service bulletin

M90-6 Technical Portions Are FAA Approved

26 February 1990

SUBJECT: **INSPECTION AND REPLACEMENT OF SCAVENGE PUMP GEARS
P/N 635334 AND 639388**

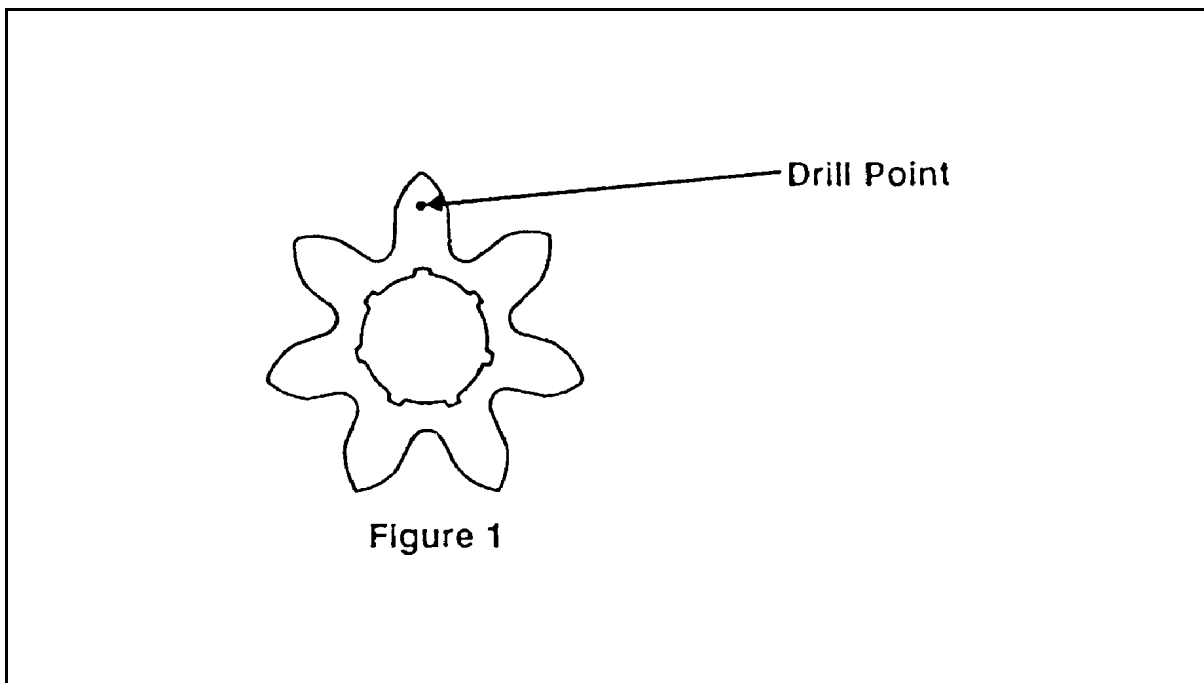
It may be that p/n 649157 and 649159 have been previously installed in the pump during an overhaul or other servicing. Gears removed from a pump may be inspected to determine if they are 649157 and 649159. Prior to inspection, the scavenge pump gears should be cleaned with an approved carbon cleaner and thoroughly rinsed with a mineral spirit solvent. 649157 and 649159 gears can be identified by a drill point on the end of one gear tooth as shown in figure 1.

1. Gears so identified may be reused in the scavenge pump after the visual and dimensional inspection outlined below. Some earlier 649157 and 649159 gears do not have the drill point marking but may be identified by means of a hardness test. The hardness test must be performed in a Rockwell tester with the test point in the same location as the drill point shown in figure 1. If the gears test above 56 Rc or 79 Ra, then the gears are 649157 and 649159. (Rockwell A scale testing is recommended in order to minimize the test indentation.)

Gears intended for reuse should be visually inspected for uneven wear, pitting or excessive galling. A light amount of polishing is normal and acceptable. If the gears pass this visual inspection then they should be inspected to the dimensions specified in the Table of Limits and Magnaflux procedures found in the TSIO520 Permold Series Overhaul Manual X30574A. If the gears pass all of these test they may be reused. All other affected model scavenge pump gears must be replaced with serviceable 649157 and 649159 gears.

CAUTION...Do not abrasive blast gears. This may remove surface hardness which can cause excessive wear in service.
